HISTORIC PRESERVATION BOARD

HISTORIC PRESERVATION BOARD MEETING

**STAFF MEMORANDUM
HISTORIC PRESERVATION PROGRAM
PLANNING AND URBAN DEVELOPMENT**

TO: Chair Pollard and Members of the Historic Preservation Board
FROM: Rob Wiener, Historic Preservation Compliance Coordinator
DATE: October 14, 2022
RE: 99 Capisic Street, Addition and New Garage / Guest House - PUBLIC HEARING
PROJECT ID: HPBR-002024-2022
MEETING: October 19, 2022

ISSUED: 09-26-22
PROJECT No: 2201
DRAWN BY: SD
CHECKED BY: CB
SHEET TITLE:
EXTERIOR
ELEVATIONS

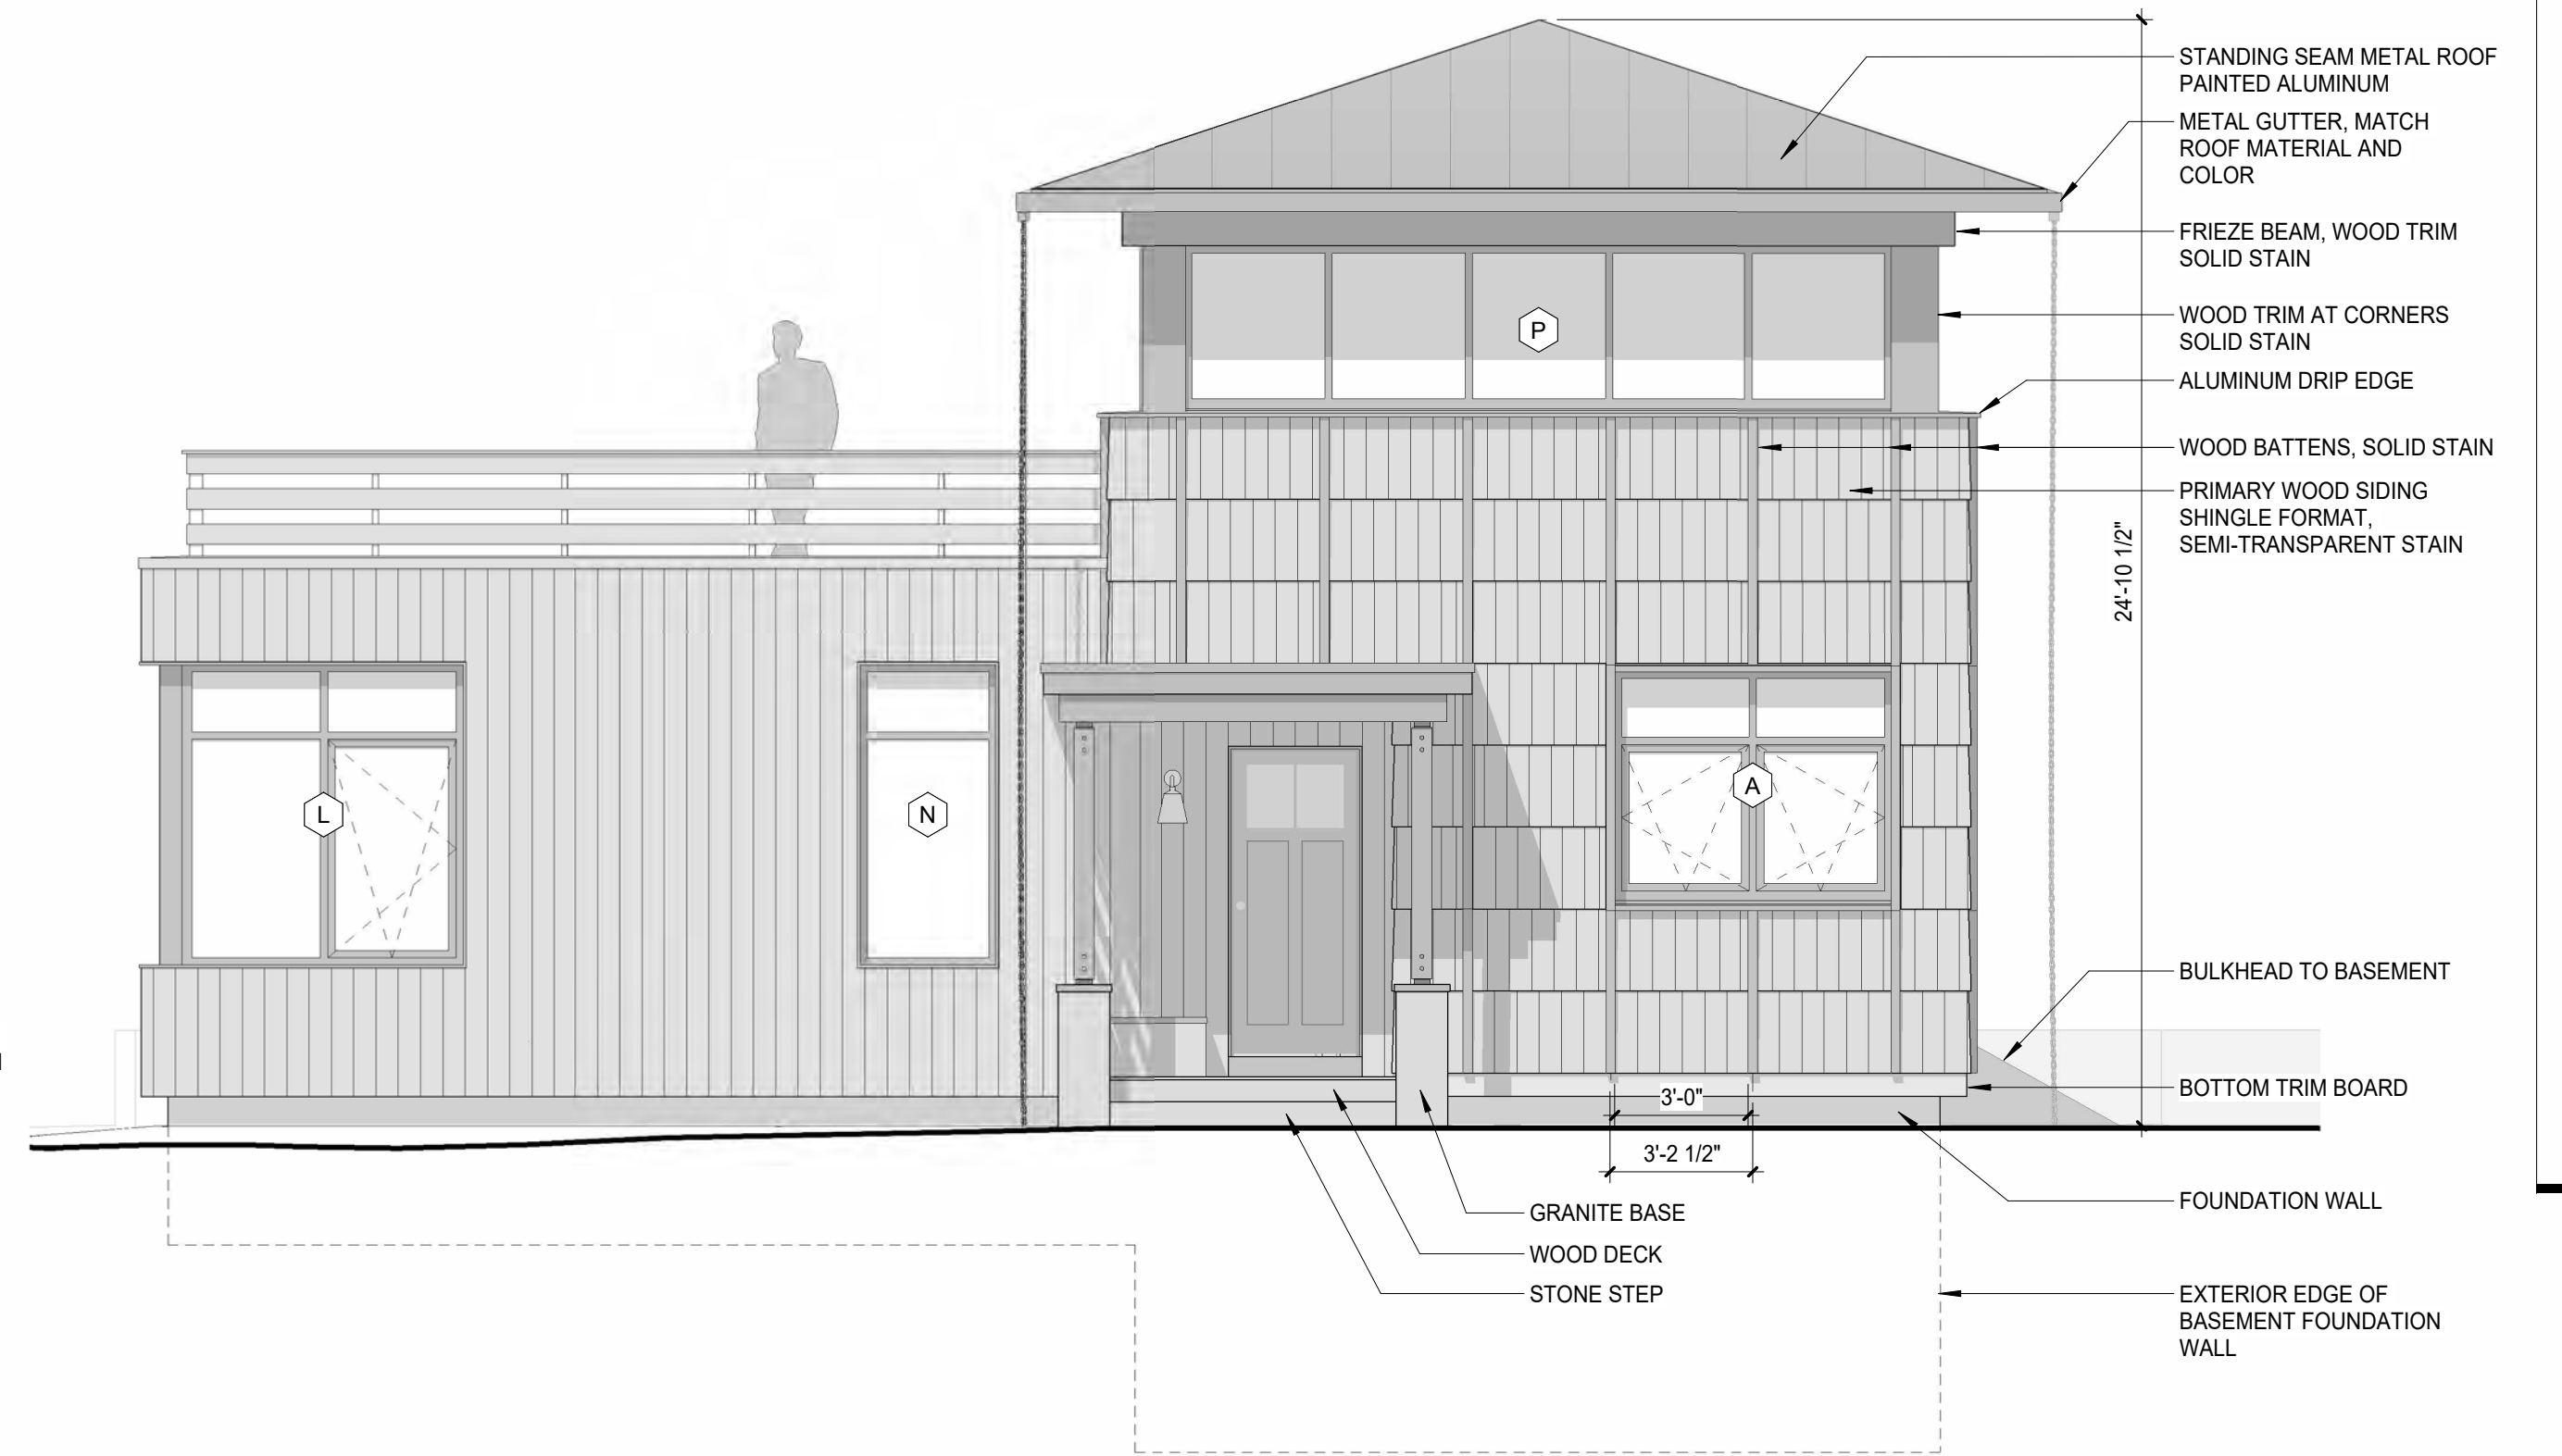
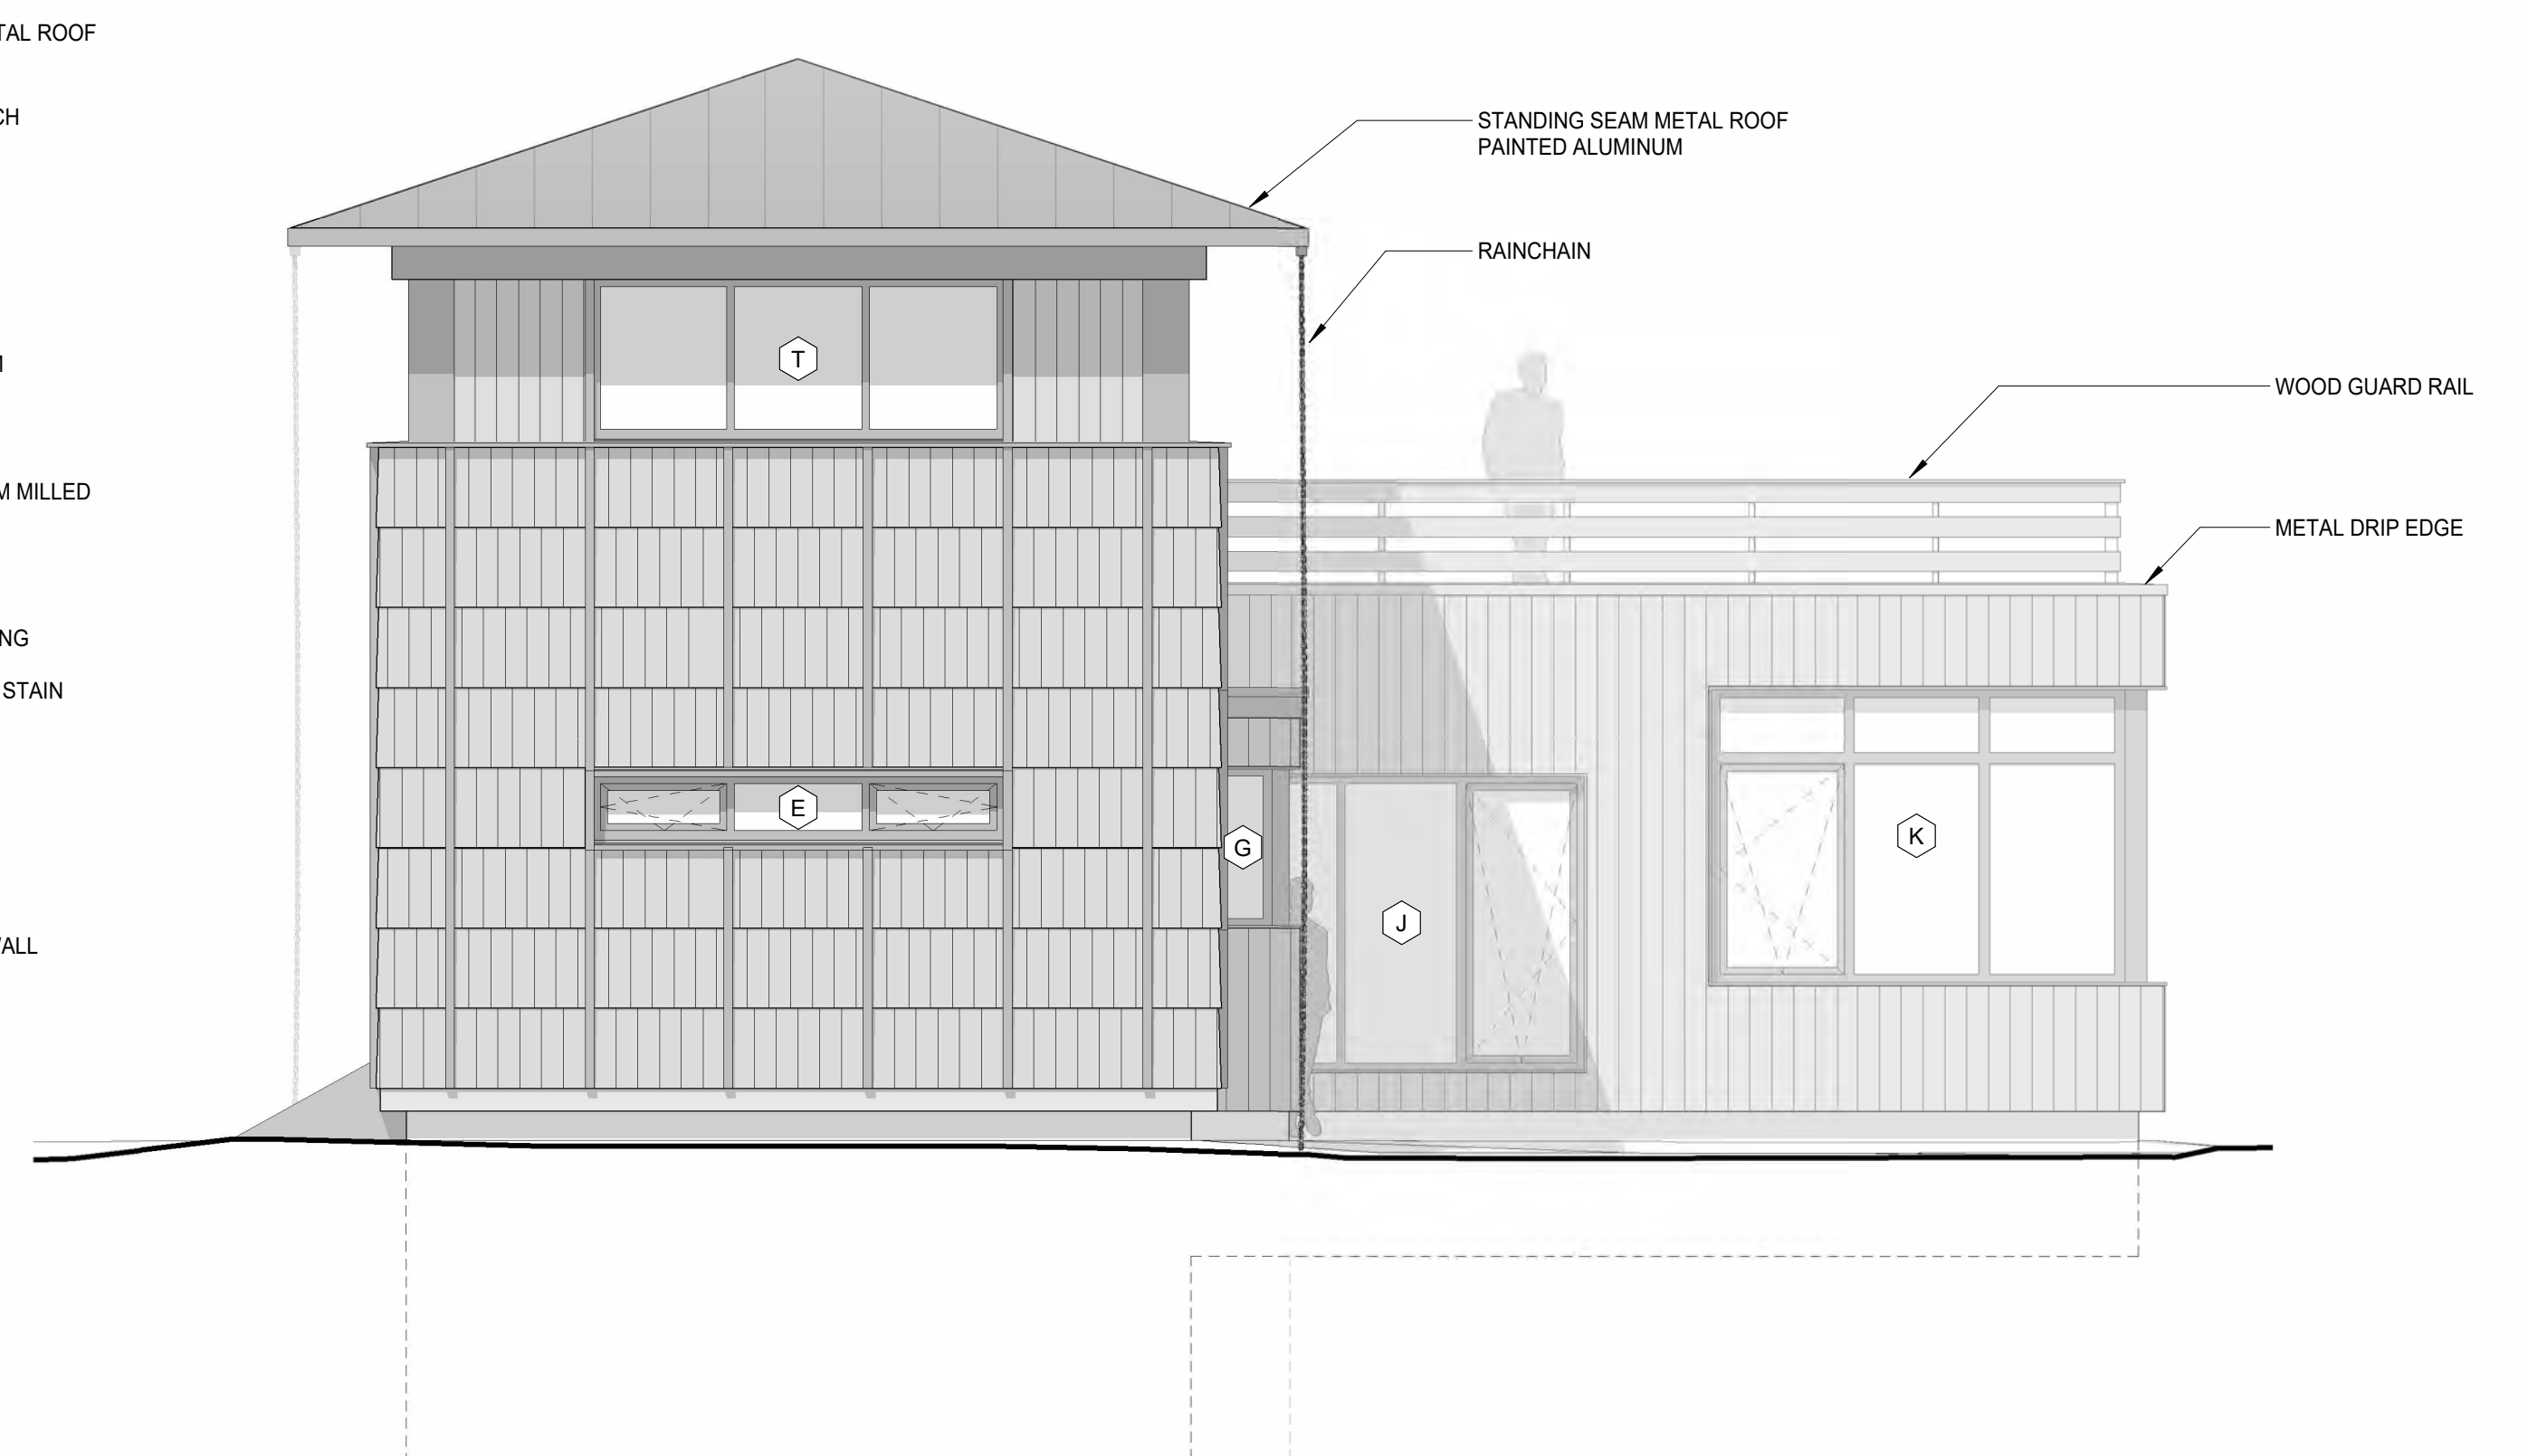
The revised proportions of the windows are the most significant change in the design. The first floor, southernmost window on the west elevation has been given a much more vertical orientation and has been reduced to covering only two bays of the exterior as opposed to three. This gives the window a more balanced relationship with the porch. The windows at the one-story north wing have also been altered to have more vertical proportions. Additionally, the second story windows have been redesigned such that each unit is taller than it is wide, whereas they were originally proposed to be wider than they were tall. Generally, these revised window proportions are more compatible with the typical window proportions found in the West End Historic District.

Related to this, at the first floor, south elevation, the second entrance off of the driveway has been eliminated and the window closer to the southwest corner has been revised to match the adjacent window on the west elevation. The door has been replaced with a single width window with the same sill and head height. While the Board had not previously expressed opposition to the side door, its elimination does help to generally make the primary entry more prominent as the only way into the building from Chadwick Street.
